*Bridge Preliminary Design Report  
Addendum*

**Ramp B over Norfolk Southern Tracks  
SCI-823-1598**

**SCI-823-10.13  
PID No. 79977**

Prepared for  
**Ohio Department of Transportation**

**Site Plan - Sheet 1 of 3**

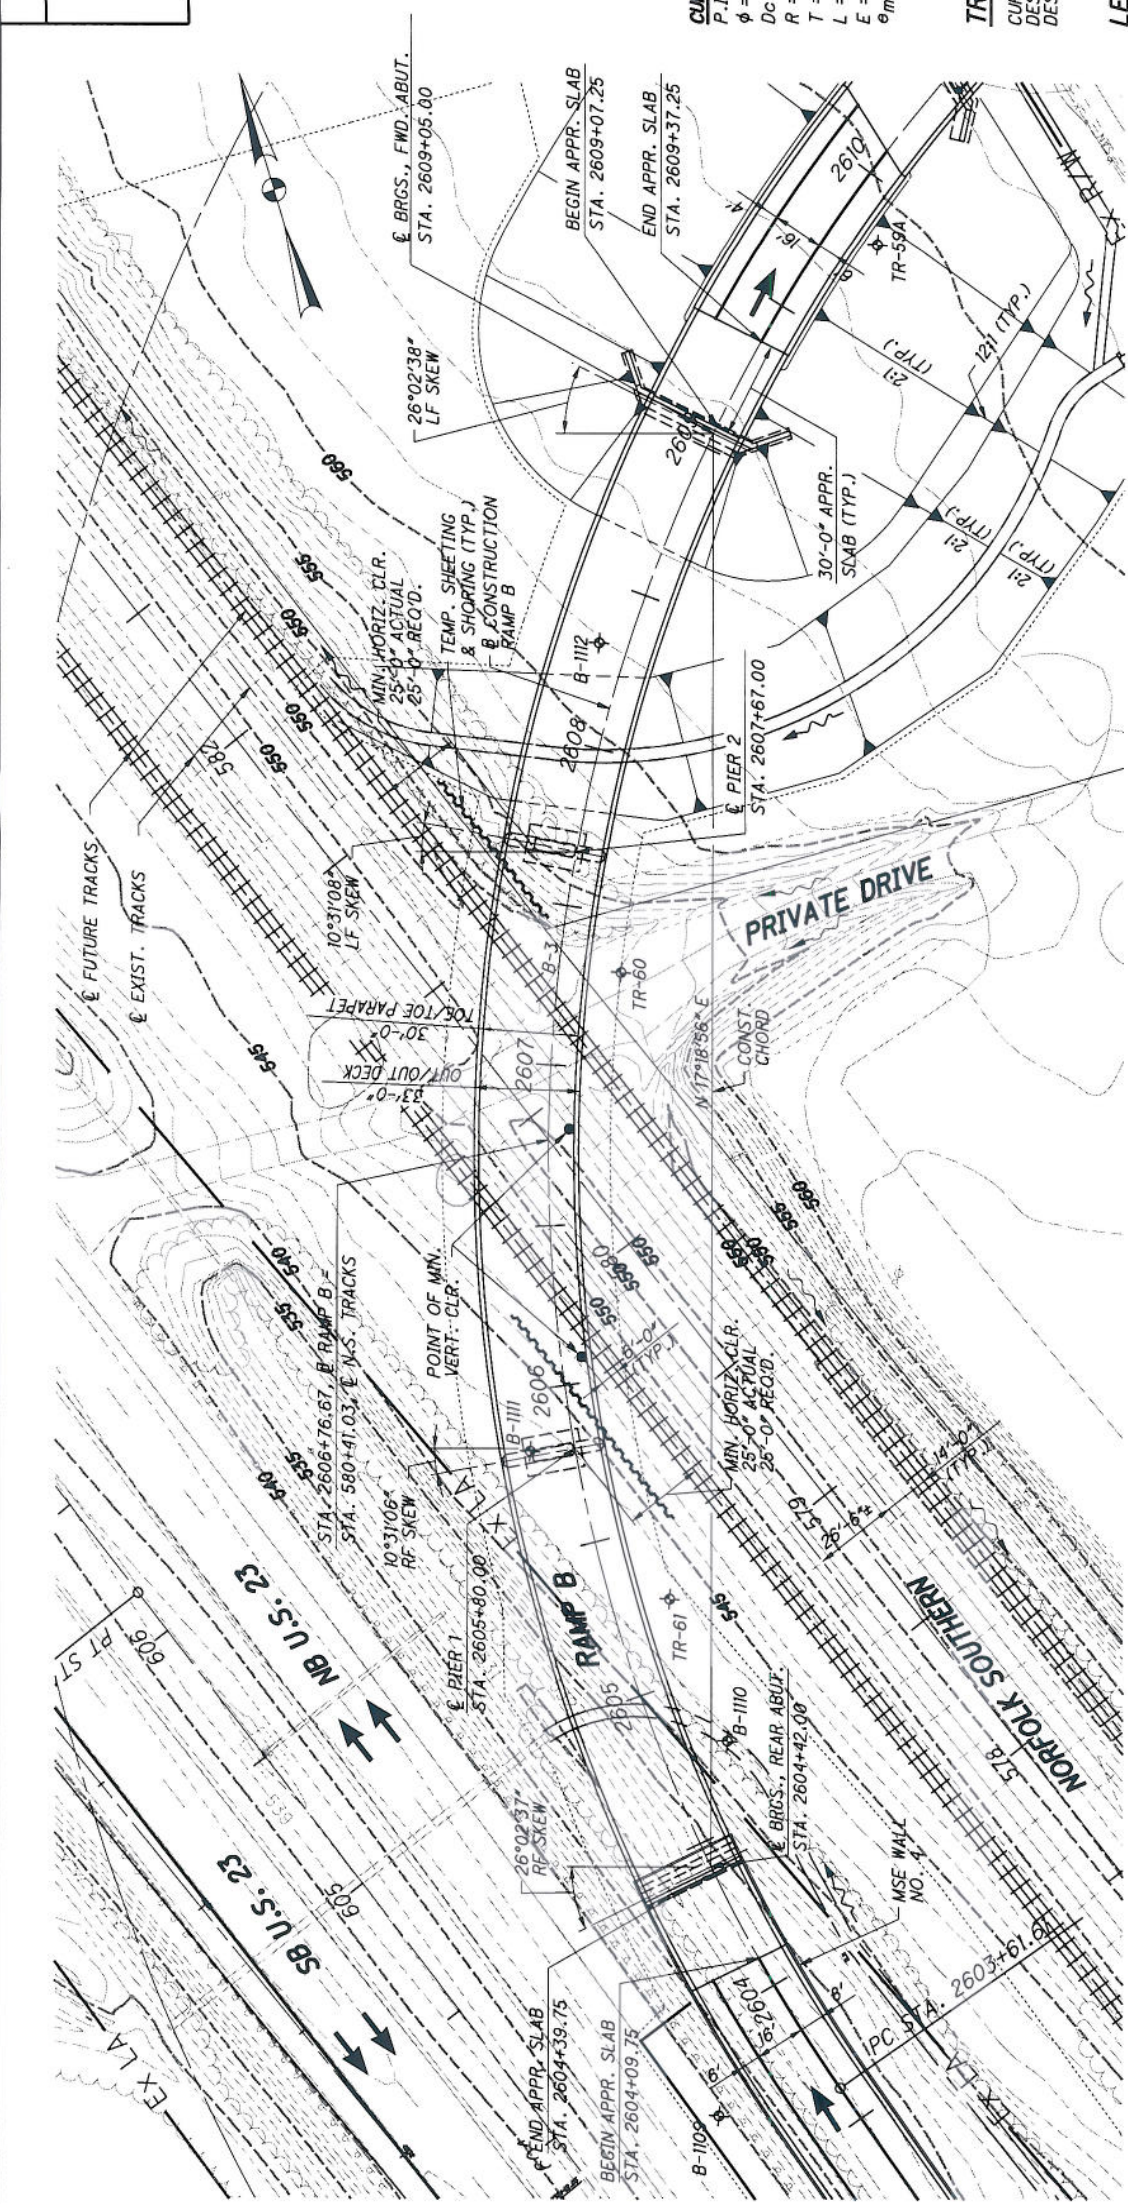
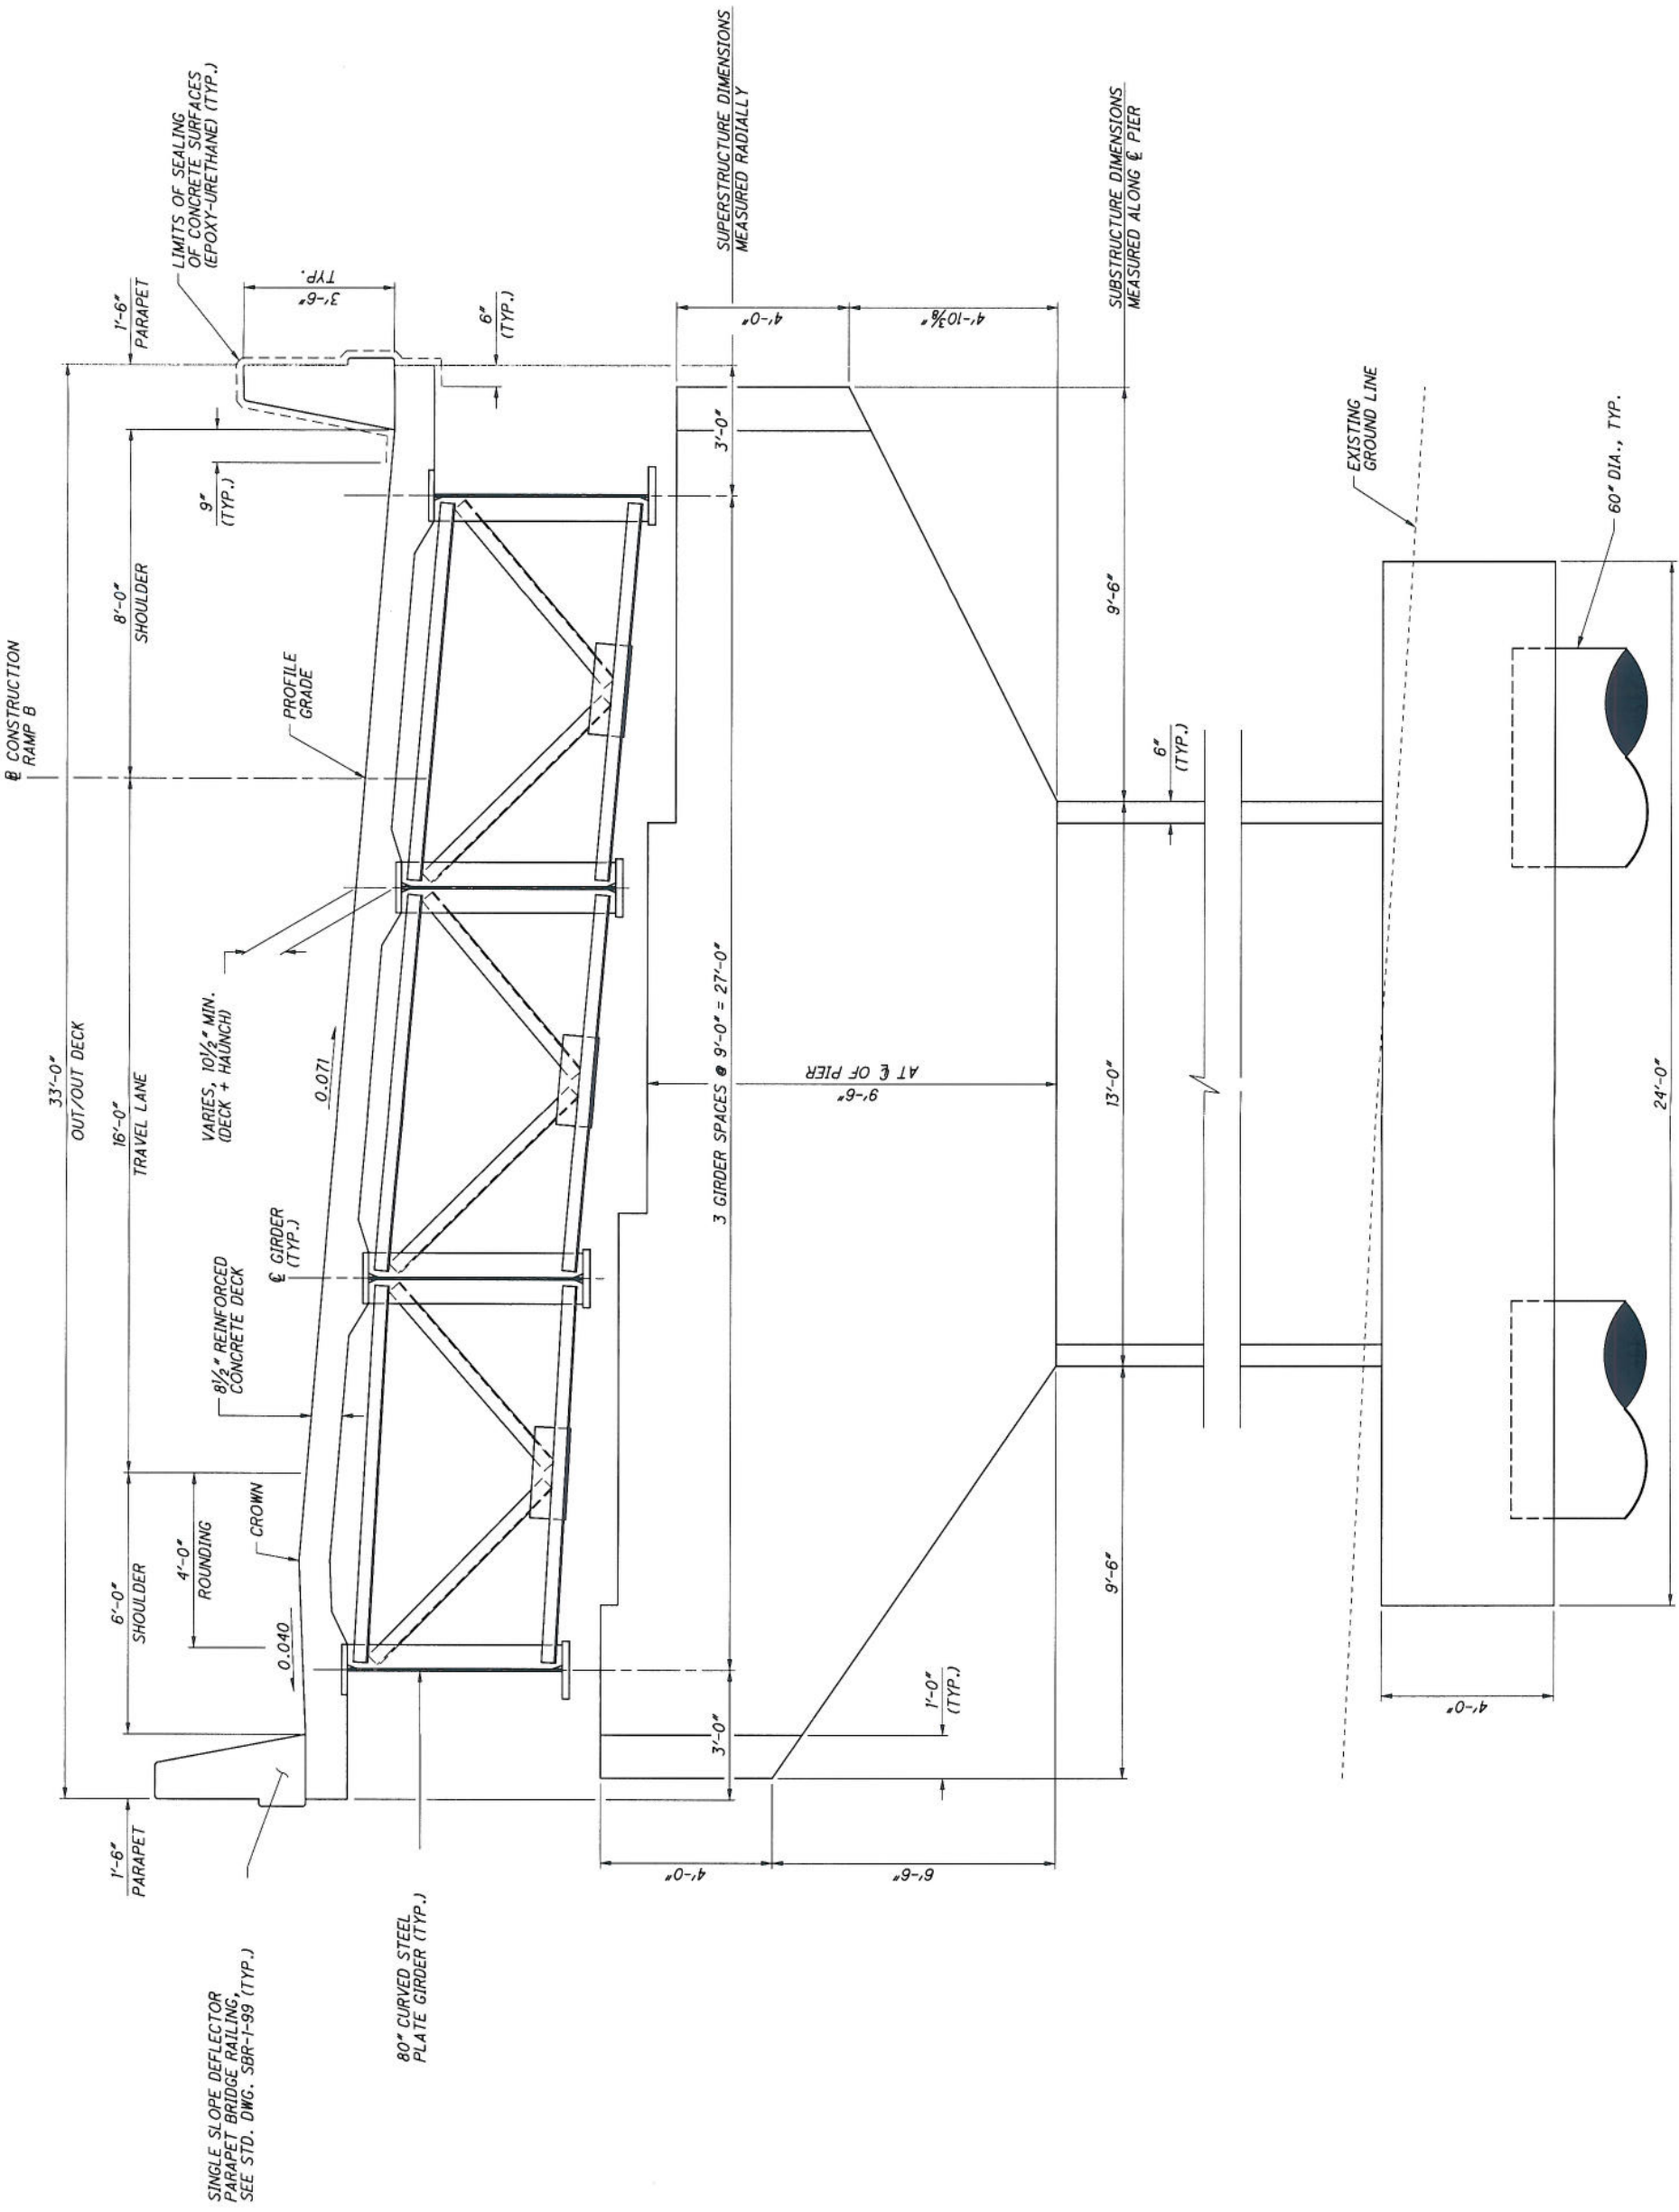
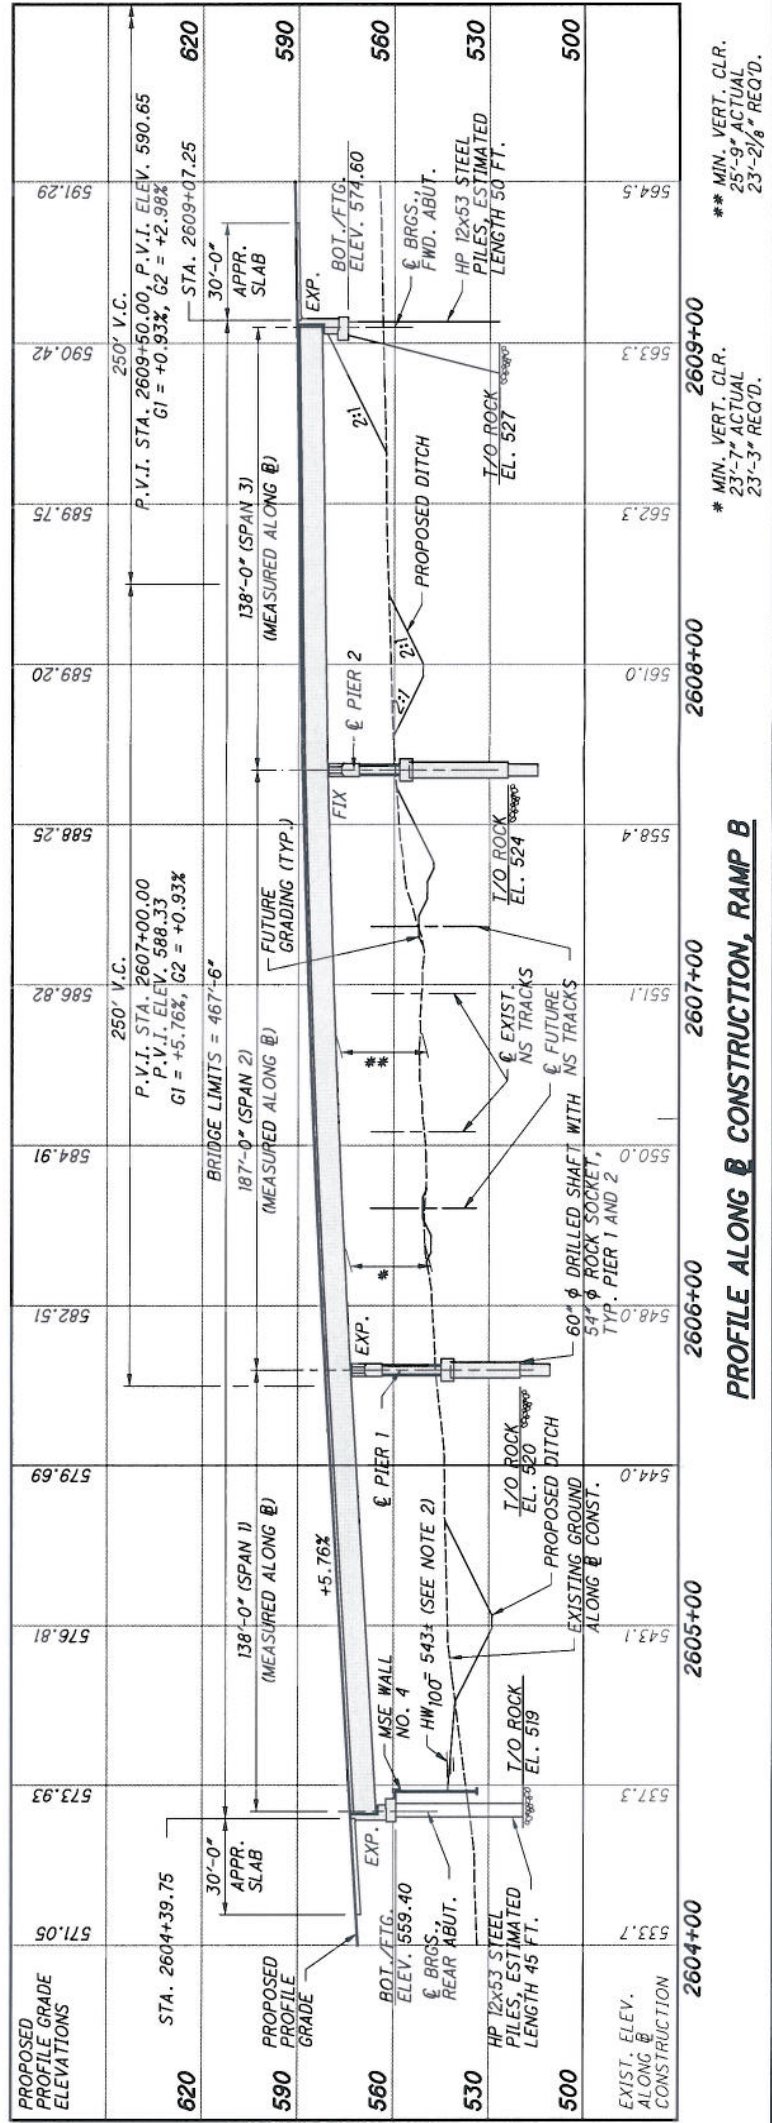
5. The actual unfactored design loads of 75 tons and 95 tons correspond to HP10x42 and HP12x53, respectively. Please refer to BDM 202.2.3.2.a which was updated in the 2007 Fourth Quarter Revisions. The increase in the maximum allowable design loads for H-piles driven to refusal is to take advantage of the Grade 50 steel that is now used for steel piles.
6. Please provide the location and description of benchmarks in the next submittal. (BDM 202.2.1)
7. In the Proposed Structure data block, Length of Span on curved alignments should be measured along a reference line which is a chord drawn from centerline of abutment bearings at the centerline of survey or baseline of construction. (BDM 202.2.1)

6	Please provide the location and description of benchmarks in the next submittal. (BDM 202.2.1)	Benchmark information will be provided as soon as that information is available.
7	In the Proposed Structure data block, Length of Span on curved alignments should be measured along a reference line which is a chord drawn from centerline of abutment bearings at the centerline of survey or baseline of construction. (BDM 202.2.1)	Acknowledged. Span lengths will be measured along the construction chord and Proposed Structure data block will be updated accordingly.
